**SAN ANTONIO WATER SYSTEM
HIGHLAND ESTATES, UNIT 1 P.U.D. MONTANA PASS FLOATING GROUND
STORAGE TANK PROJECT**

**SAWS JOB NUMBER 15-1177
SOLICITATION NO. CO-00092**

**ADDENDUM NO. 5
October 13, 2016**

MAP No. _____ SHEET T-6R1
SECT. No. _____
DR. CK. JOB No. 15-1177

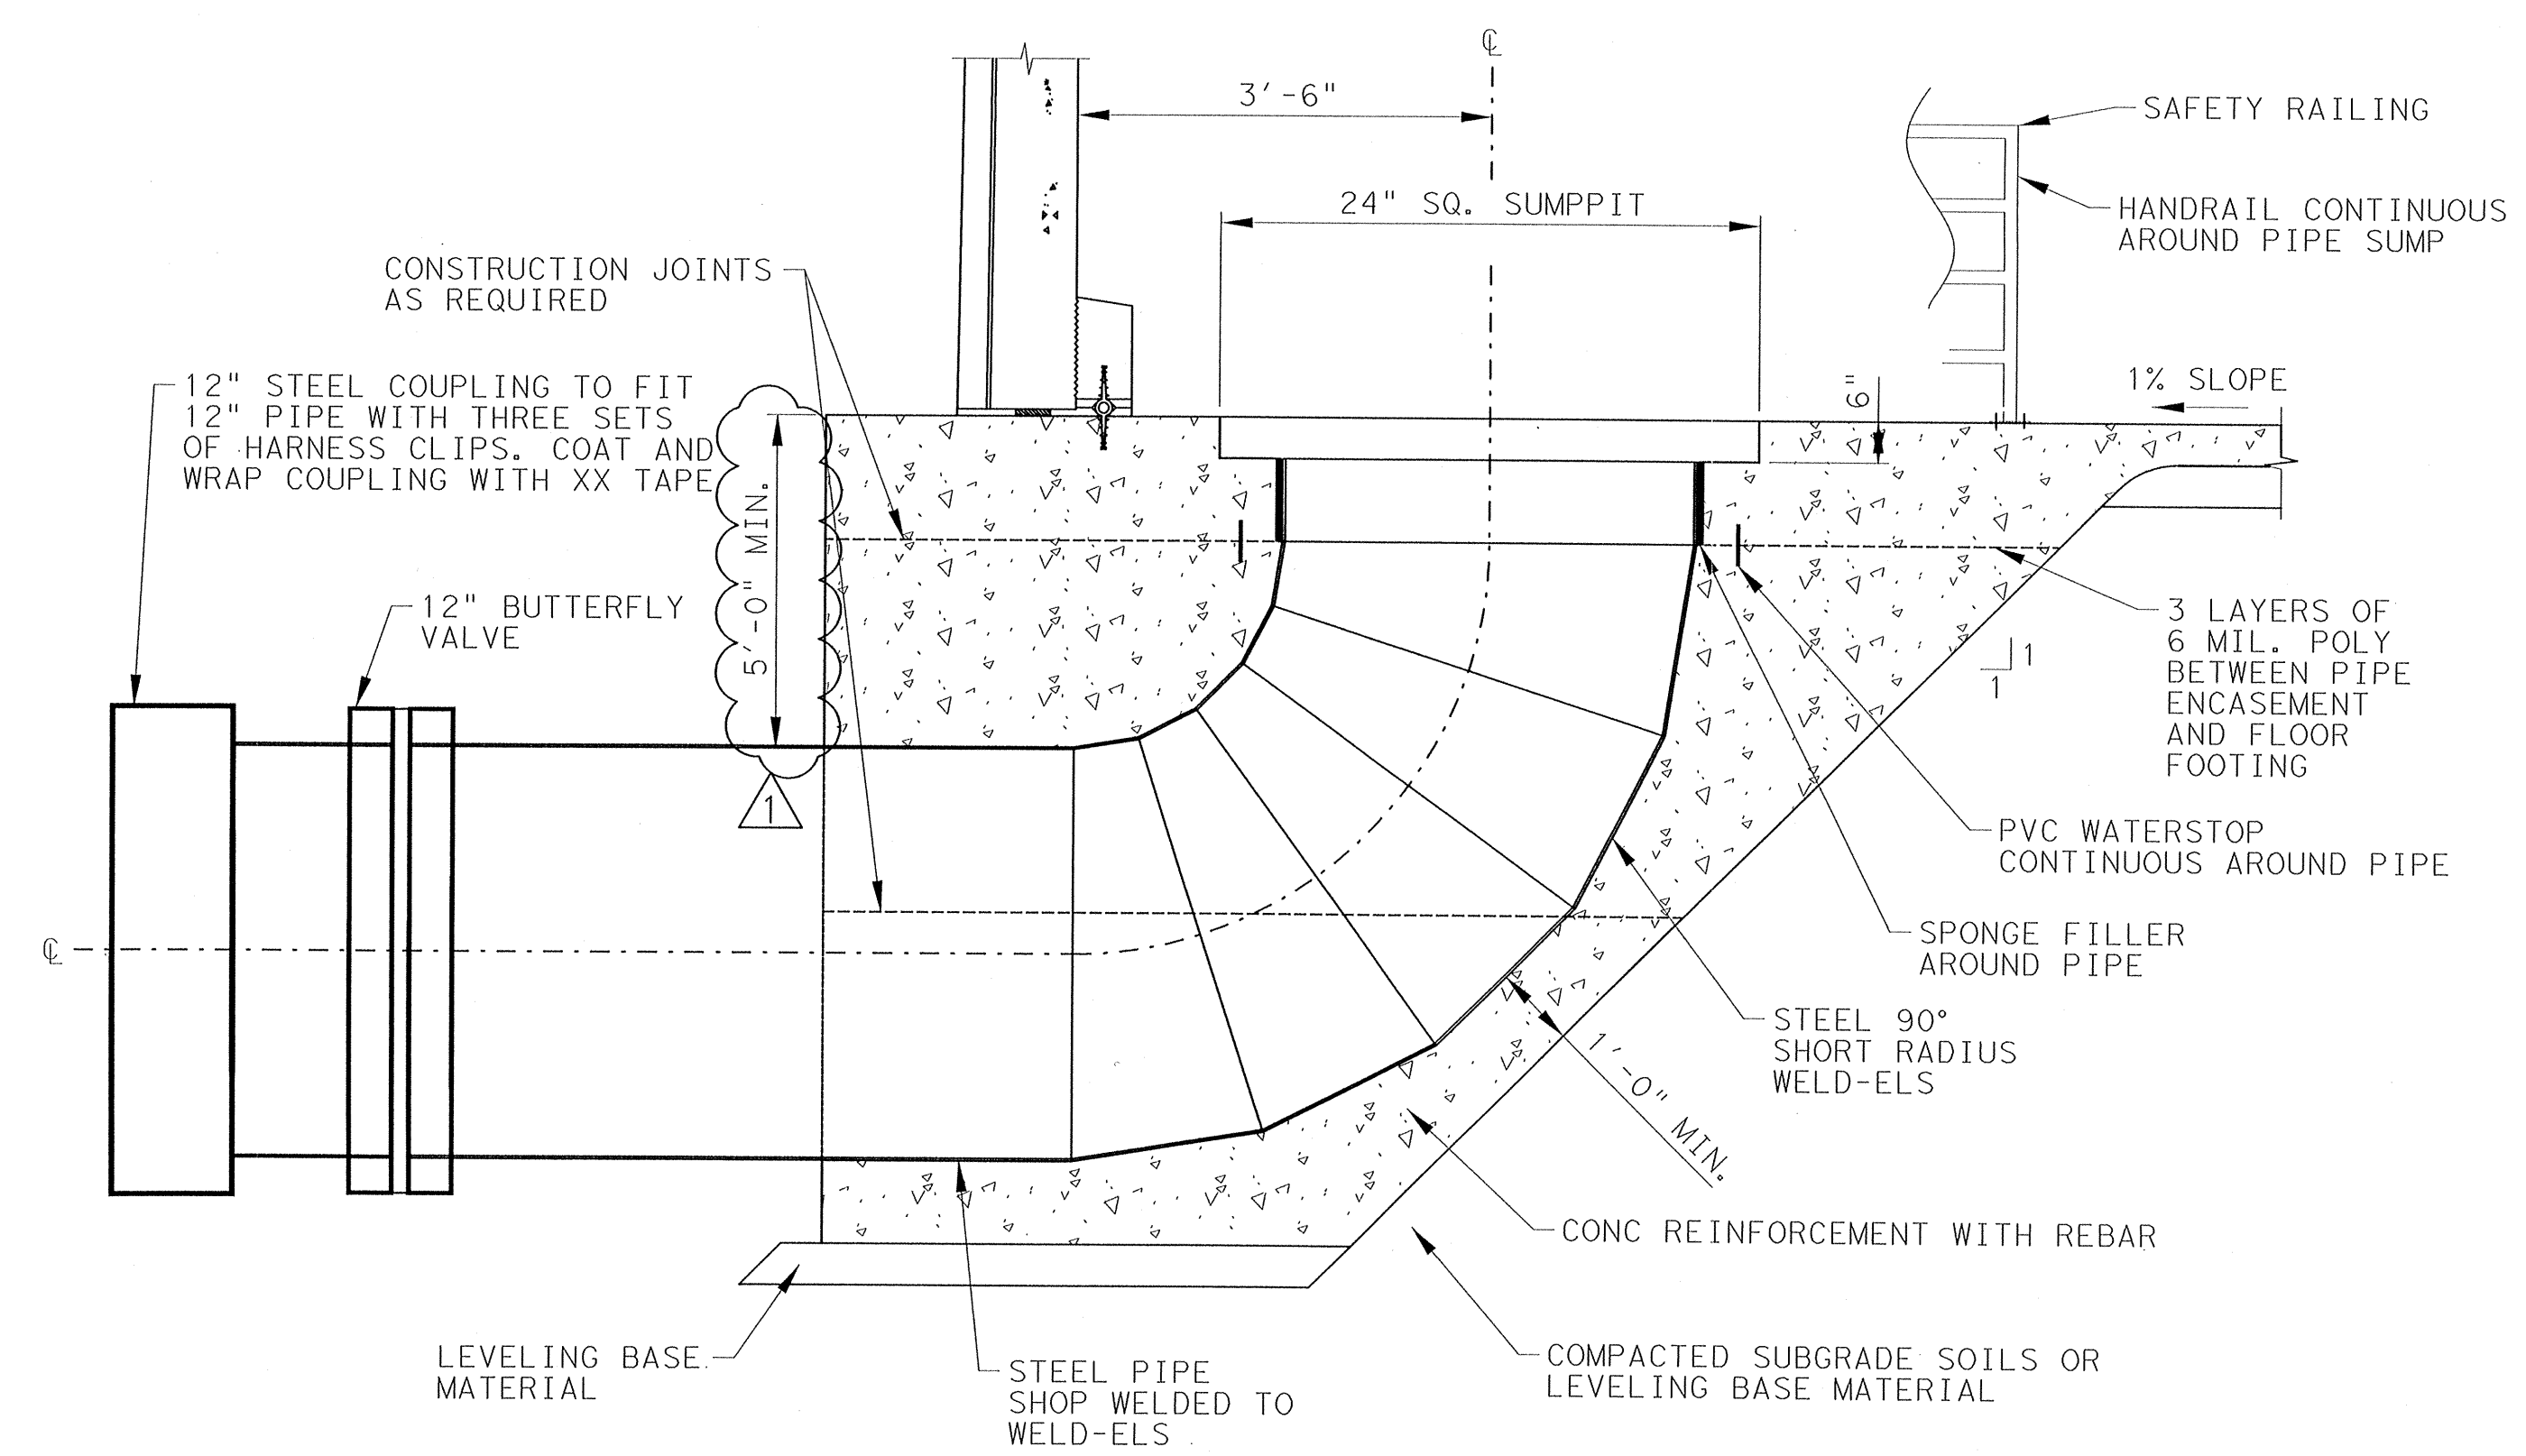
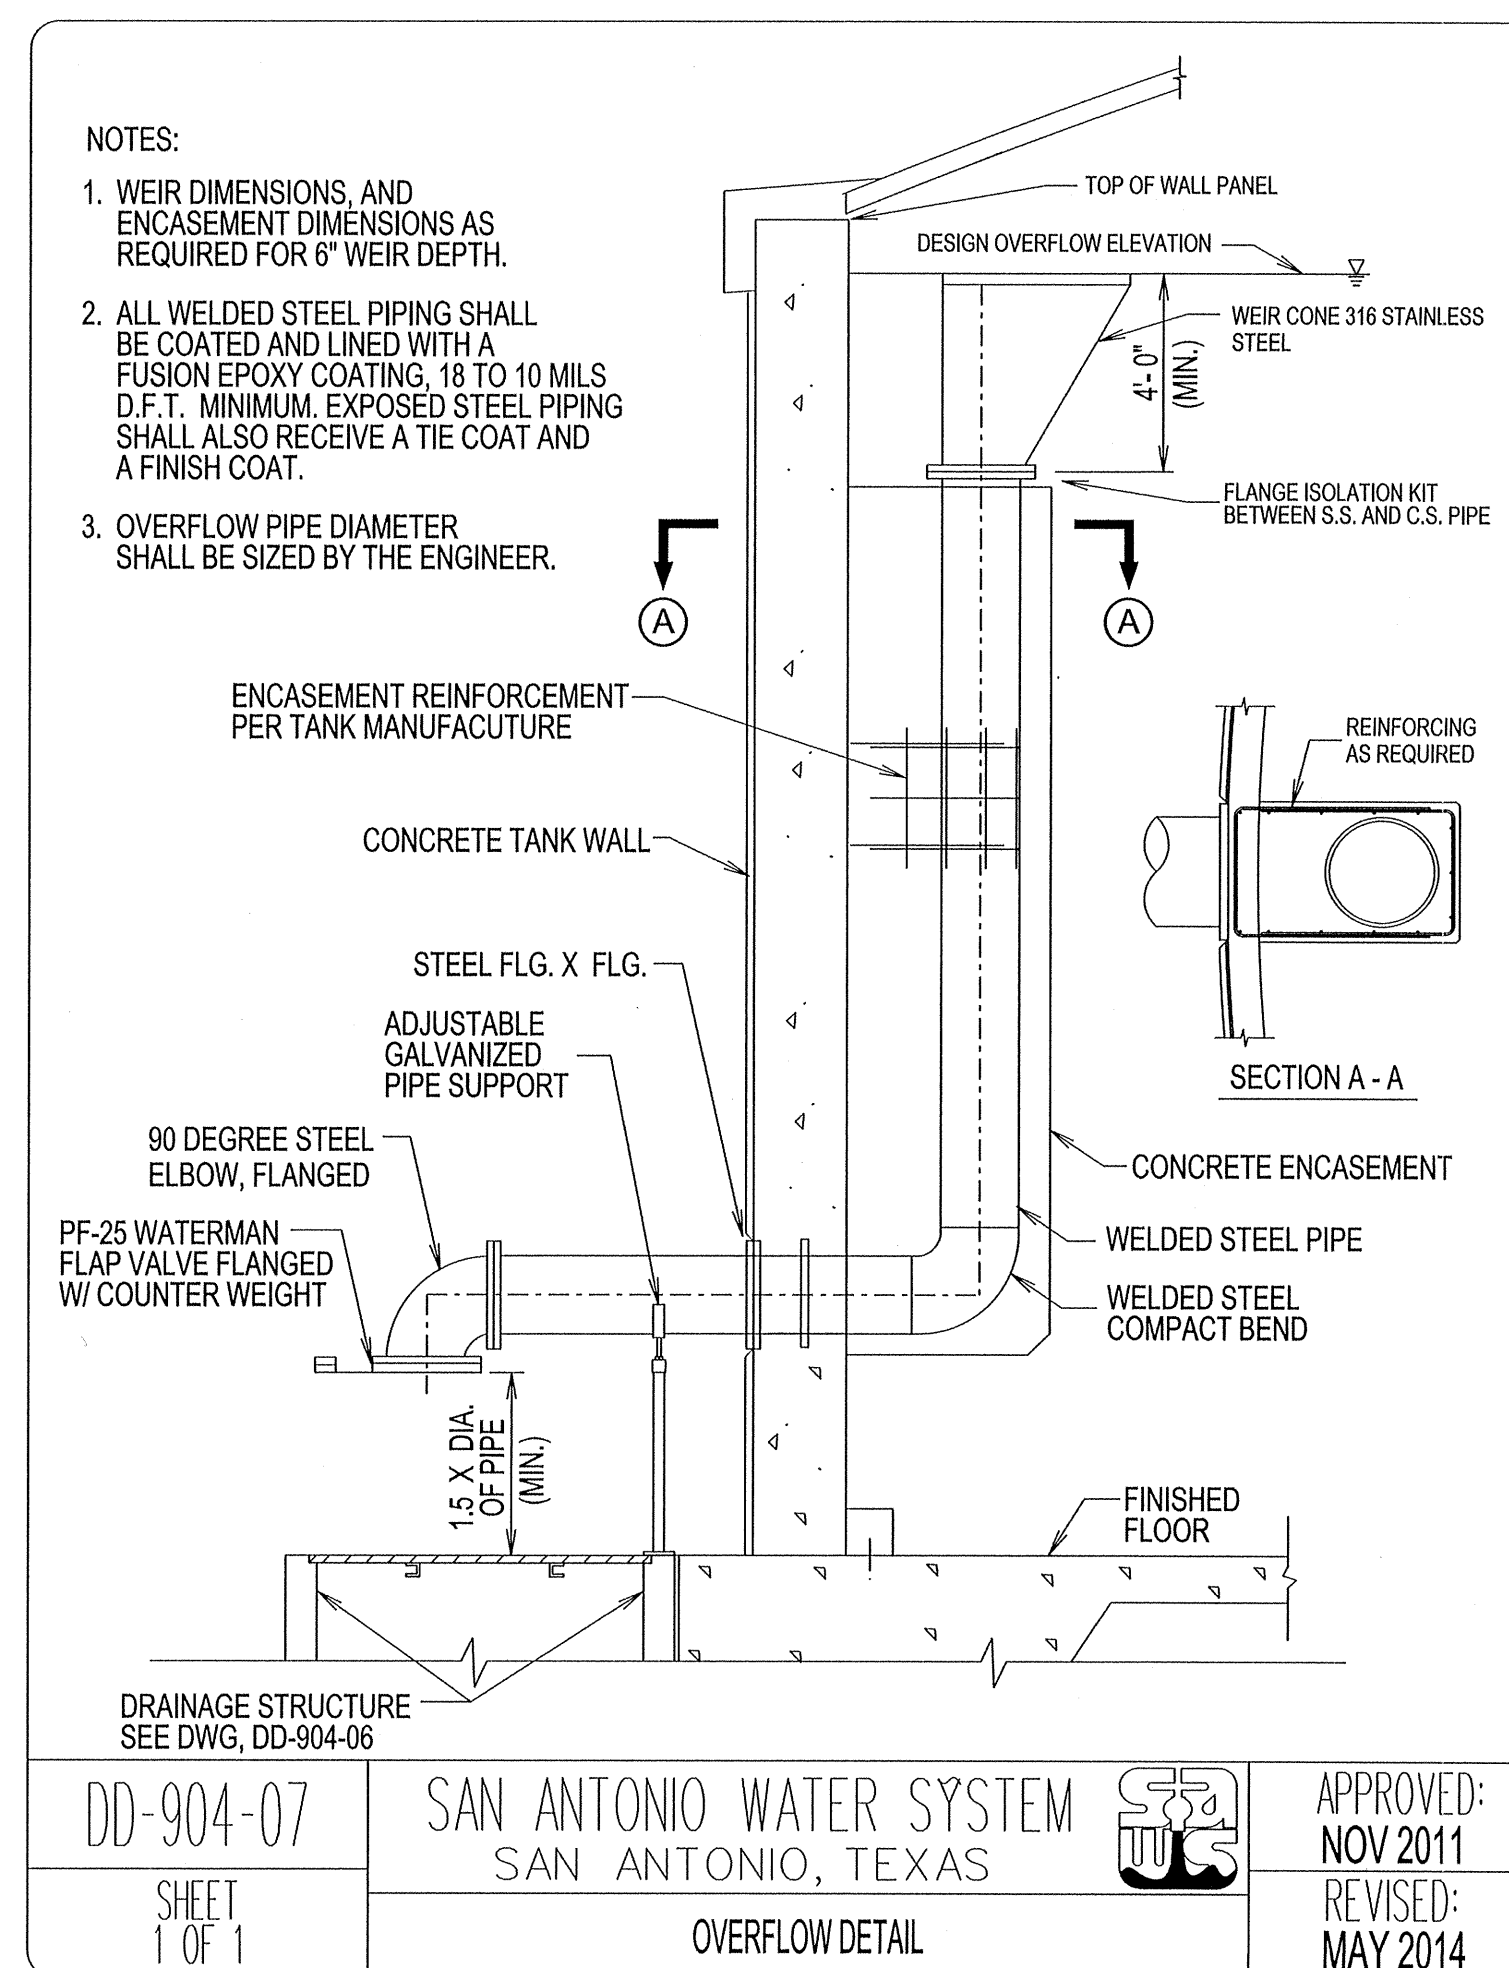
8. Sheet T-6, indicates all of the pipes shall have 3’-0” min. cover from the tank finish floor elevation. Sheets C-6.1 and C-6.2 indicate the pipes shall have 5’-0” minimum cover from finish grade. Please confirm the bury depth or centerline elevation for all tank piping.
Minimum cover on pipes shall be 5’. Refer to revised Sheet T-6R1 attached as part of this addendum.

9. Sheet T-2, please confirm the handrail material for the tank dome.
Handrail material is 1½” Schedule 40 stainless steel 316L pipe. Reference Pipe Safety Railing detail on Sheet T6R1.
